UNITED STATES PATENT AND TRADEMARK OFFICE

APPLICATION NO.	FILING DATE	FIRST NAMED INVENTOR	ATTORNEY DOCKET NO.	CONFIRMATION NO.
10/732,970	12/11/2003	Theodore W. Houston	TI-35974	8532

Office Action Summary	Application No. 10/732,970	Applicant(s) HOUSTON, THEODORE W.	
	Examiner TRONG PHAN	Art Unit 2827

DETAILED ACTION

FIG. 5

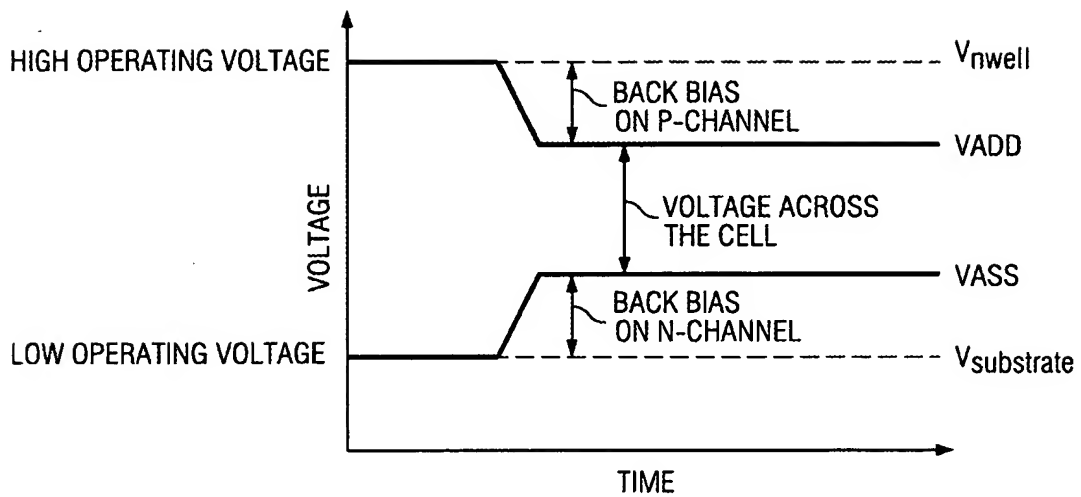
Newly added Fig. 5 was not described in the original specification, therefore, it constitutes a new subject matter. It should be noted that new Fig. 5 shows the voltage across the cell clearly higher than the back bias on p-channel and also higher than the back bias n-channel; and the low operating voltage is clearly the same as the $V_{\text{substrate}}$.

g) newly added Fig. 5 constitutes a new subject matter;

DISAPPROVED
TP
9/19/06
